DISPATCH

Hangar Curtains for []

LAY OUT PLAN

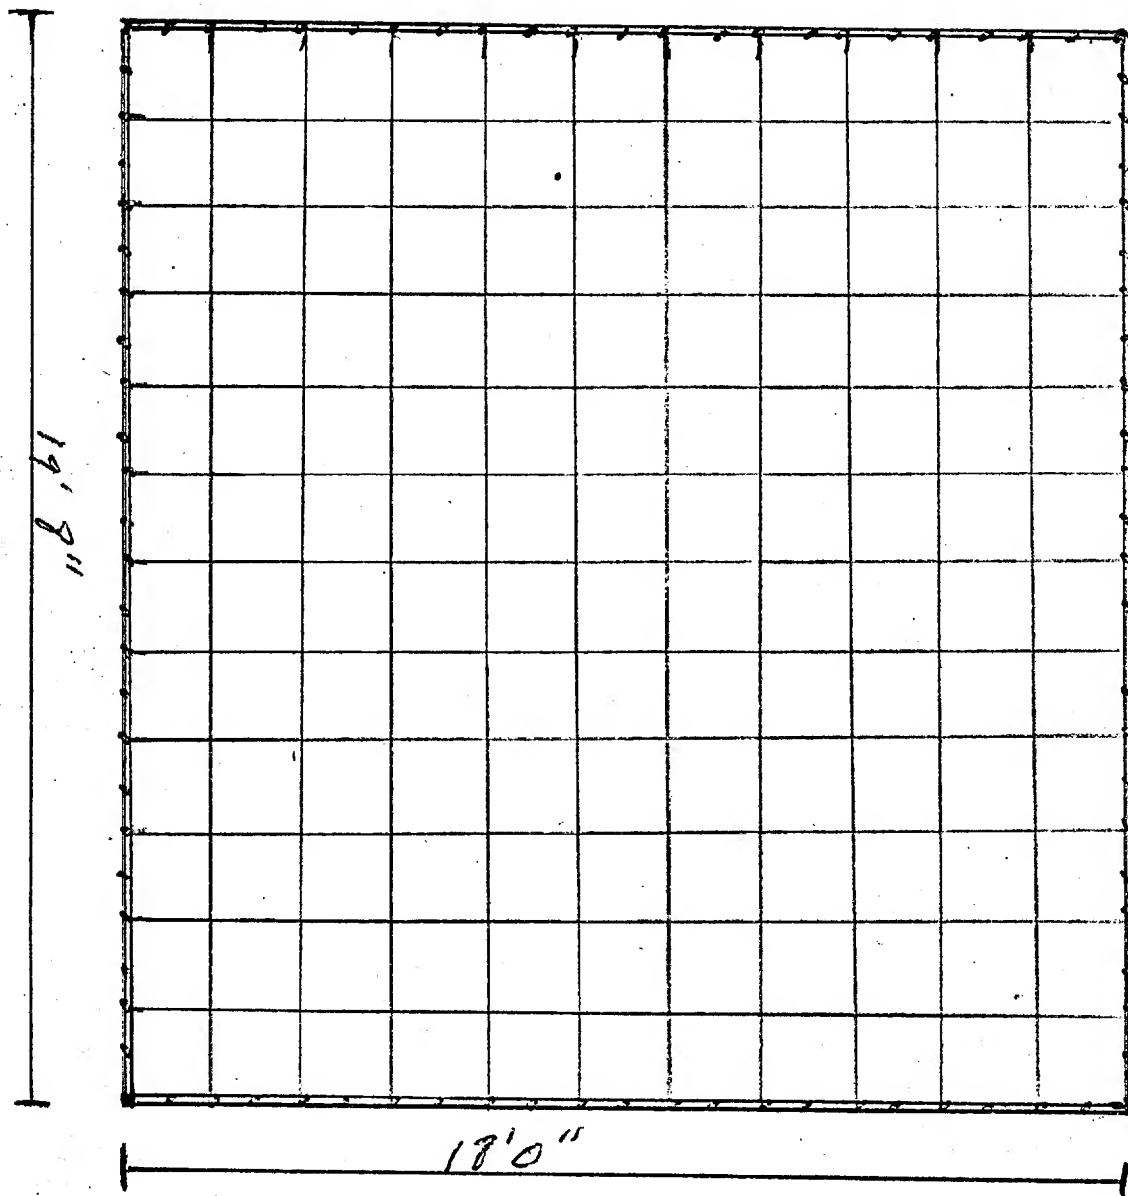
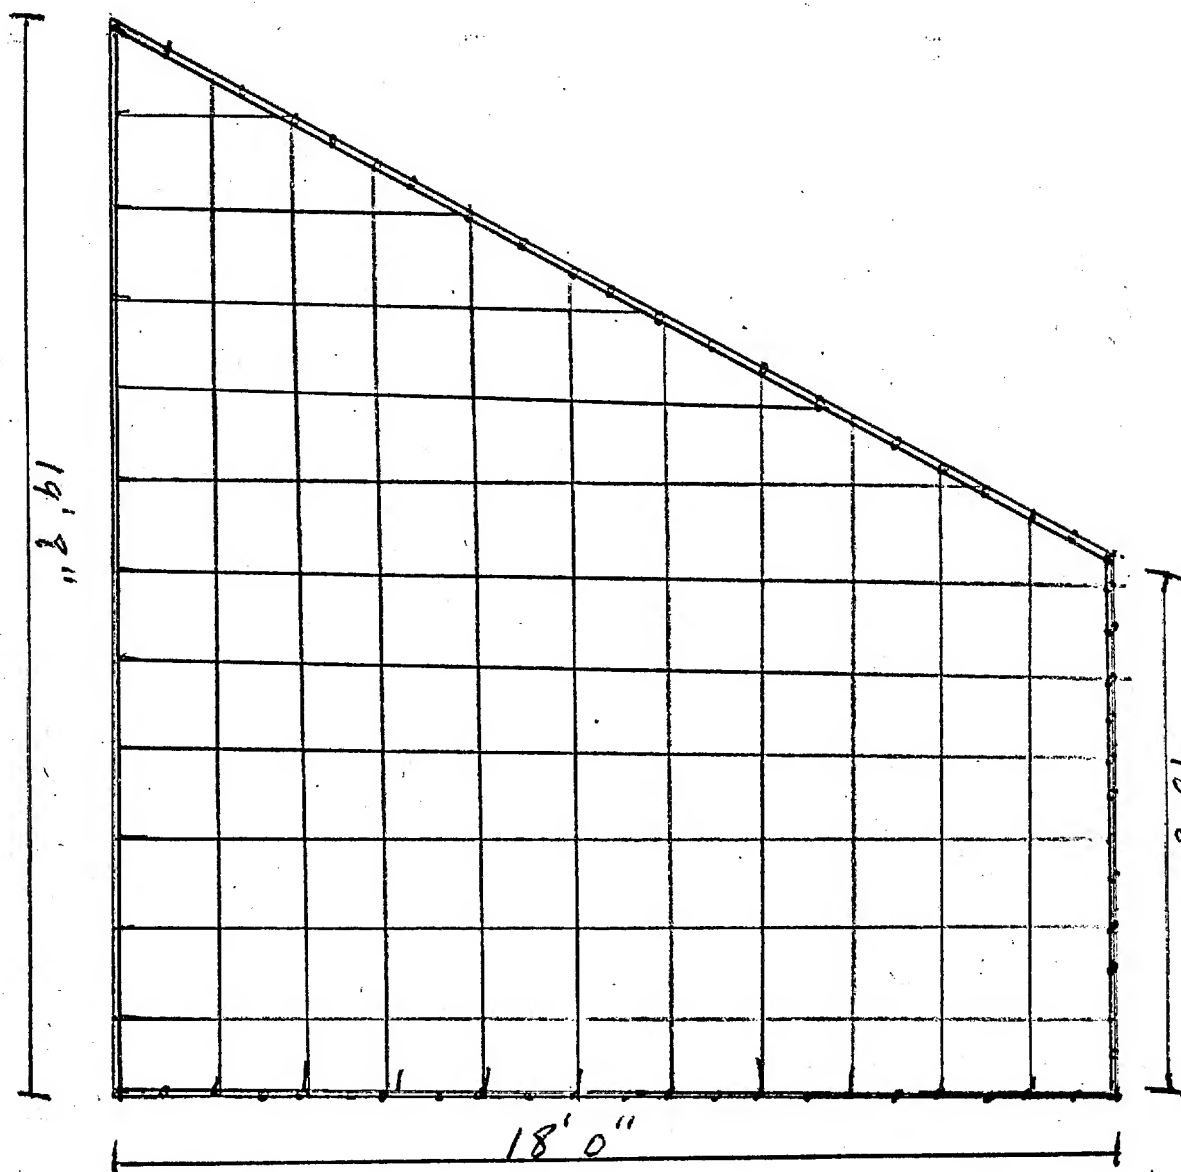
1. During recent operations at [] the hangar curtains provided by [] proved inadequate. This failure can be directly attributed to (a) cables and turn-buckles were made of galvanized iron and not steel (b) curtain material was of a poor quality canvas (c) curtain eyelets were not adequately reinforced.

2. The attached drawings are forwarded for your use in making up specifications for their manufacture in []

1. 3" nylon webbing to be double stitched on both edges of webbing. *THIS WEBBING RUNS AROUND OUTSIDE OF EACH CURTAIN*
2. All seams to be 1" double folded and double stitched.
3. 1" nylon tape to be criss-crossed every 24" (approximately) single stitched on each edge of tape.
4. Install heavy duty gromets 12" apart all around each curtain.
